**CHEROKEE NATION**

**COMMUNICATION TOWERS**

**ADDENDUM 01**

**REQUEST FOR SEALED PROPOSAL (RFP)**  
**DESIGN/BUILD: COMMUNICATION TOWERS**  
**ADDENDUM 01**

**ATTACHMENT C - CARRIER INFO EXAMPLES**

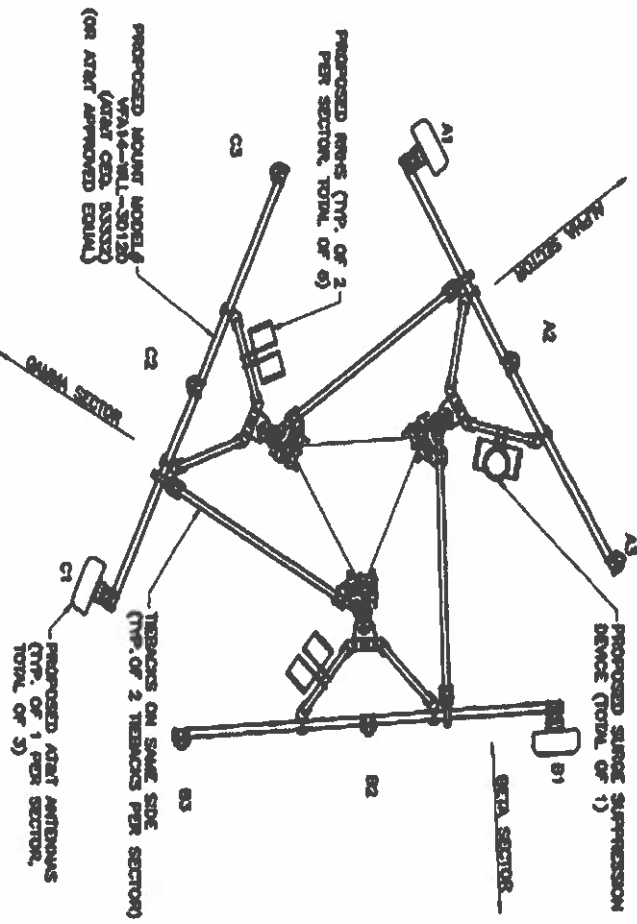
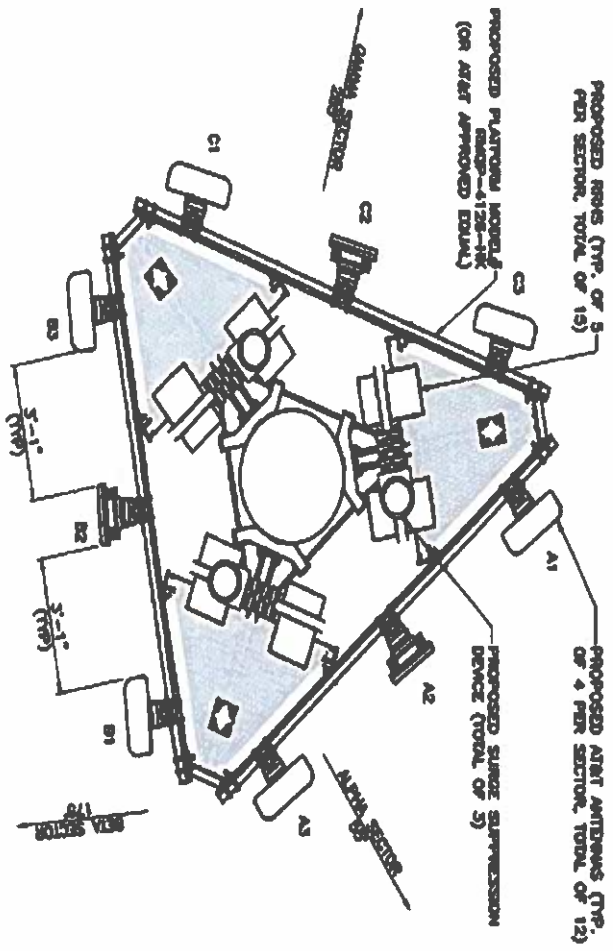
**QUESTION:** Is there any chance you could forward the tower loadings?

**QUESTION:** Can more information be provided for the antenna loading? Antenna types and elevations to be installed would be helpful.

**QUESTION:** Tower - Can you provide the intended antenna loading so we can also include the costs of brackets and mounts?

**RESPONSE:** **Low band and mid-band antenna with tower mounted RRH will be installed later. The system weight of 1 antenna and 1 RRH is an example weight of 150 lbs. Full capacity may be 4 systems with 3 sectors. See Attachment C as an example.**

**RESPONSE:** Low band and mid-band with tower-mounted RRH will be supported. The system weight of 1 antenna and 1 RRH is an example weight of 150 lbs. Full capacity may be 4 systems with 3 sectors. See Attachment C as an example.

**ATTACHMENT D - GROUNDING PER MOTOROLA R56 STANDARDS**

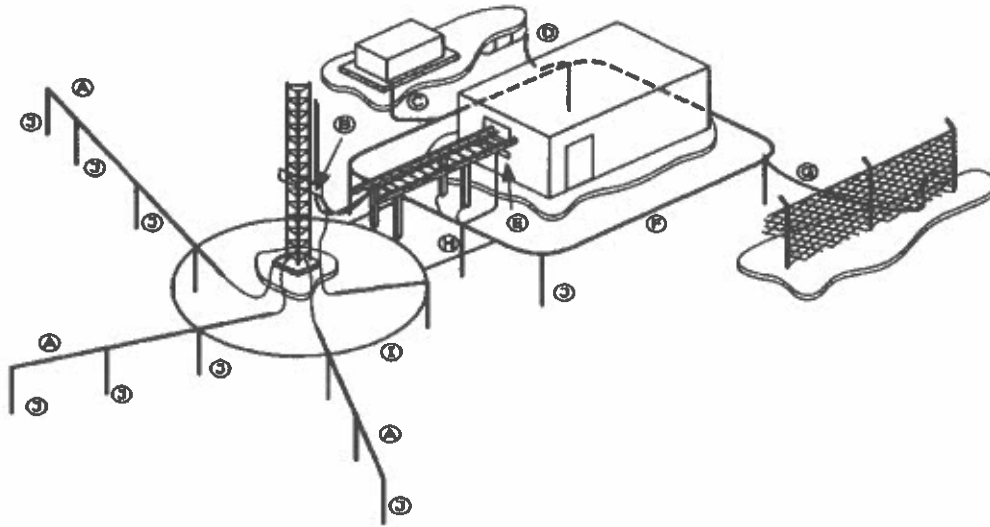
QUESTION: Grounding - Motorola R56 Standards. Will a down lead on each tower leg also be required?  
RESPONSE: **See Attachment D**
